# service bulletin

**No. 98-18**

## Second Station Start/Stop Kit Instruction Sheets

MerCruiser D2.8L and D4.2L D-Tronics

76057

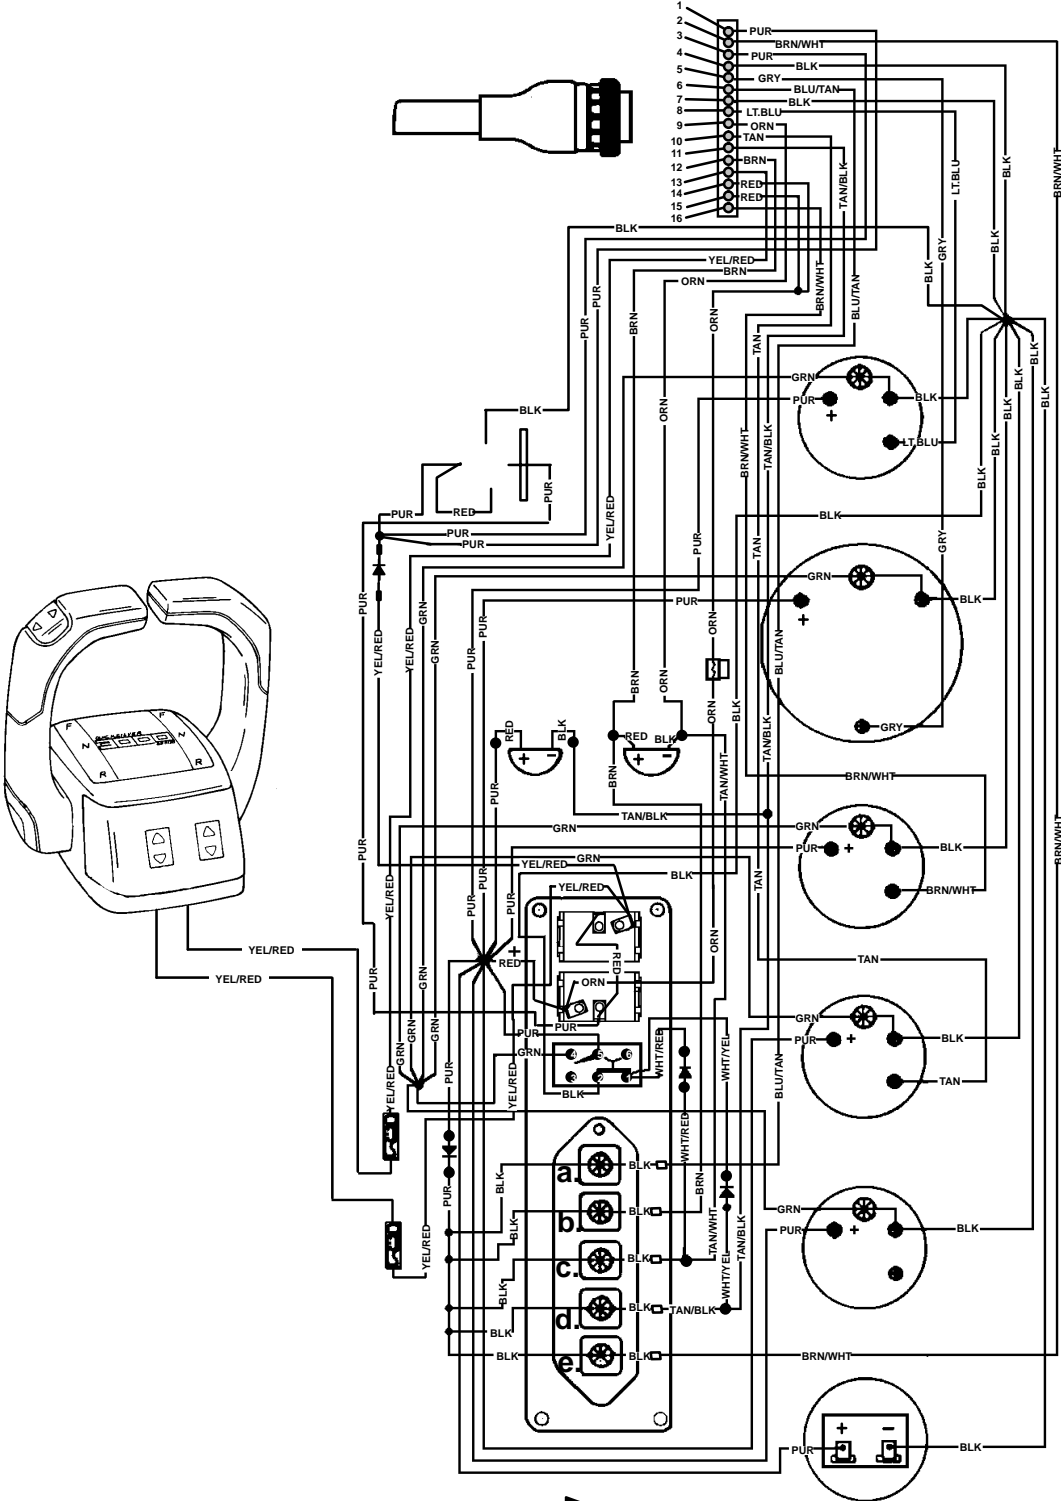
On Second Station Start/Stop Kits listed above, the instruction sheet (P/N 90-850776), shows the start/stop switch wiring reversed. If the kit you are installing has the instruction sheet part number listed, please refer to the wiring schematic on this bulletin for correct installation. The revised instruction sheet is P/N 90-850776--1.
